URGENT - Field Safety Notification Medical Device Correction

Philips HeartStart MRx Monitor/Defibrillator on exceptionally rare occasions may exhibit abnormal behavior when operating using a single battery as the sole source of power.

Figure C: AC Module Removal

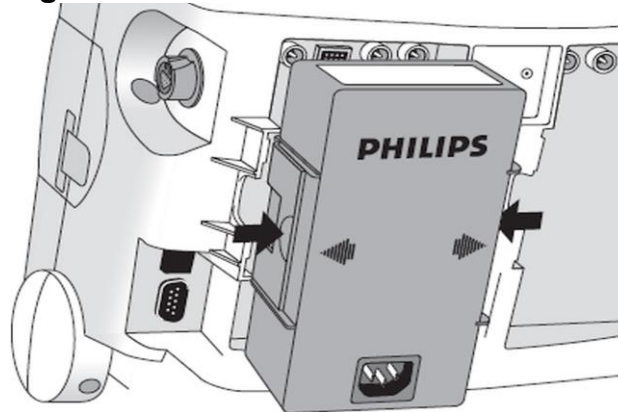
There are two ways to prevent this power switching. The user can either:

- a. Remove the AC module from the MRx, rather than unplugging the cord from AC mains (see Figure C).

<p>b. Turn on the MRx using the rotary knob and allow it to complete the start-up before unplugging the device from AC mains.</p> <p>Philips also reminds you to keep batteries fully charged before use, as per the instructions in the HeartStart MRx Monitor/Defibrillator Instructions for Use (IFU).</p>
ACTIONS PLANNED BY PHILIPS - 2	<p>Philips is voluntarily initiating this correction and is providing measures to prevent, or methods to allow the user to correct, the abnormal device behavior related to charging and pacing after disconnecting the device from AC mains.</p> <p>Philips is evaluating both software and hardware changes to prevent this abnormal device behavior. Once the solution is available, you will be contacted by Philips if you have a device that is at risk of exhibiting this issue.</p>
